TECHNICAL SERVICE BULLETIN

AWD - Hybrid - Driveline Vibration At 25-50 MPH (40-80 Km/h)

23-2072
19 September
2023

Figure 1

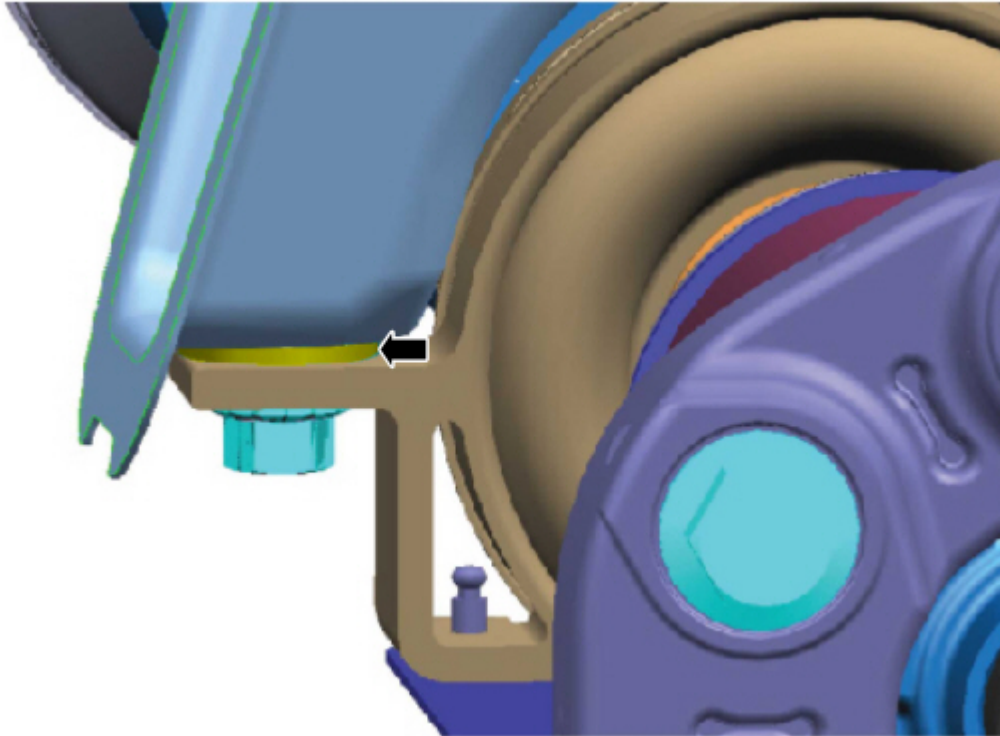
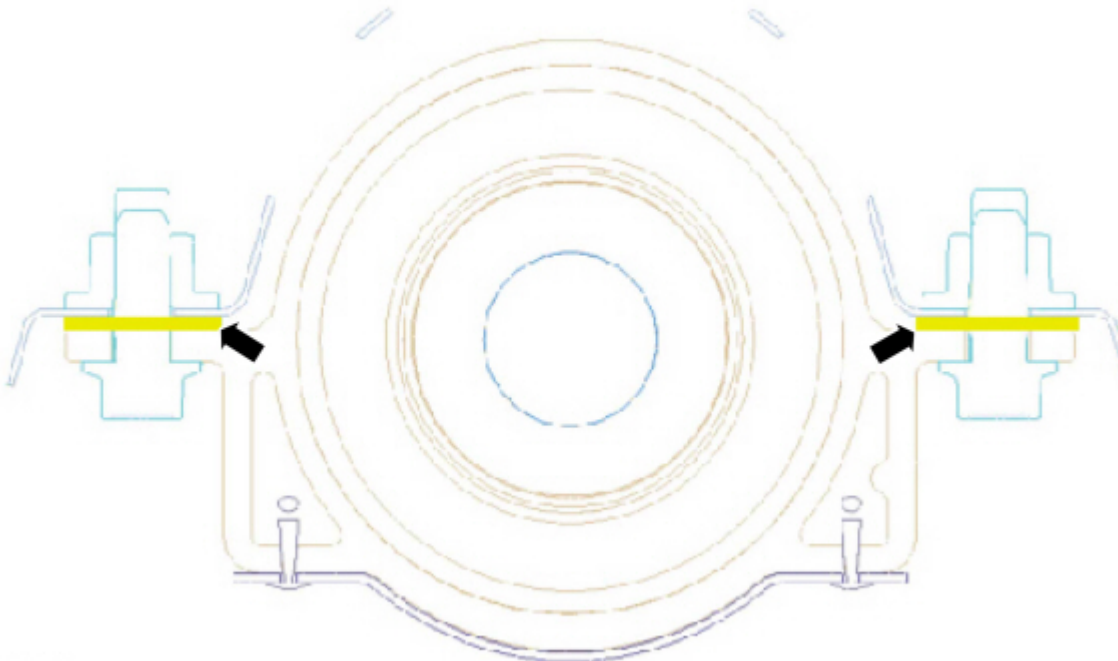
Issue: Some 2020-2023 Explorer/Aviator all-wheel drive (AWD) vehicles with a hybrid powertrain may experience a harshness and/or vibration felt through the seat, steering wheel and/or center console at 25-50 mph (40-80 km/h). This may be due to constant velocity (CV) joint instability at dynamic angles close to zero. To correct the condition, follow the Service Procedure to install a driveline shim.

2. Insert the shim between the driveshaft center bearing bracket and the body where the bolt was removed (Figures 1-2).

3. Install the longer driveshaft center bearing bracket bolt
4. Hand-tighten the driveshaft center bearing bracket bolt.
5. Repeat Steps 1-4 for the other driveshaft center bearing bracket bolt.

6. Tighten the new longer driveshaft center bearing bracket bolts to 35 lb-ft (48 Nm). Refer to Workshop Manual (WSM) Section 205-01.
